High-Priority Requests: Syracuse Urbanism Collective’s Project Recommendations for the I-81 Viaduct Project
6/24/2024, Revised 9/14/2024

Contracts 4, 5, & 6.

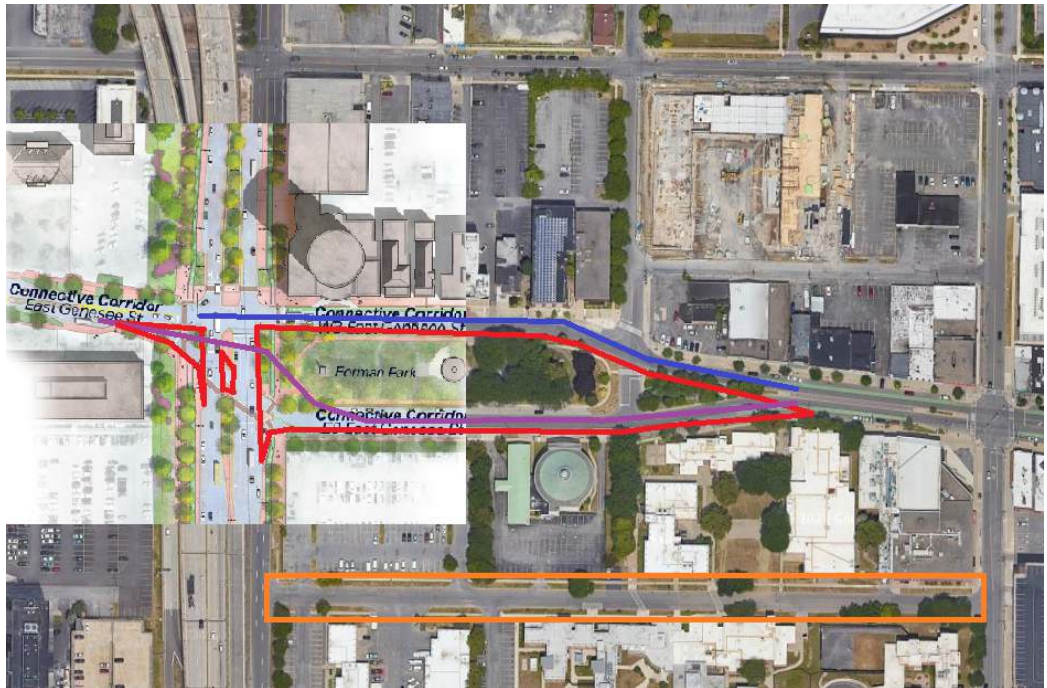
- 4. Almond Street.
 - a. The Almond Street median should be a linear park, like Commonwealth Avenue in Boston. Or, if space is limited, like the sections of NYC’s Broadway Malls containing a path down the center, such as 143-144th St, or 162-163rd St, which are only 20 ft wide. Our redesign and Broadway Malls are pictured below.
